SPEEDMASTER AND BOBBER ACCESSORY CLUTCH CABLES

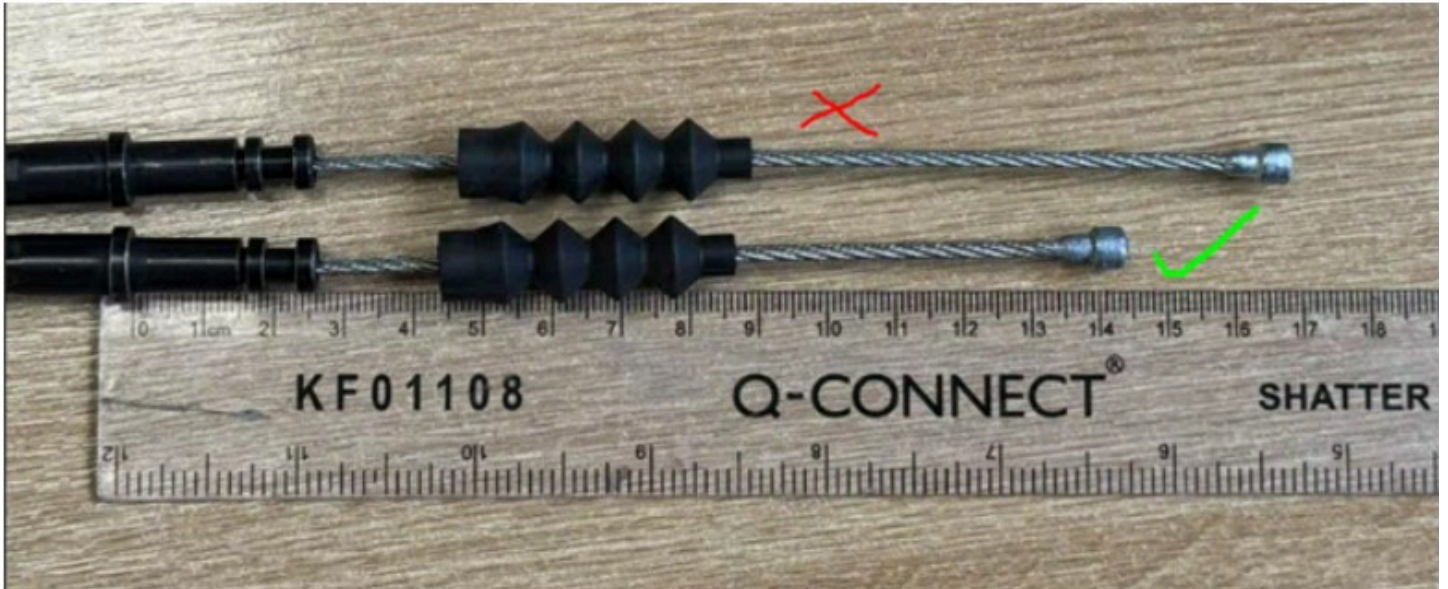
TMA has been made aware that the clutch cable (T9630240) included in high bar cables accessory kits for the Bobber (A9630253) and the Speedmaster (A9630662) could be the incorrect length. The approximate correct cable length is 138mm long beginning at the exposed section of the cable, as opposed to the incorrect cables that are approximately 150-160mm long. We would ask that, using the image below as a reference, that you check any stock of this cable or the kits to determine if you have an affected unit. If so, please email TMA Aftersales to have a replacement cable sent at no cost.
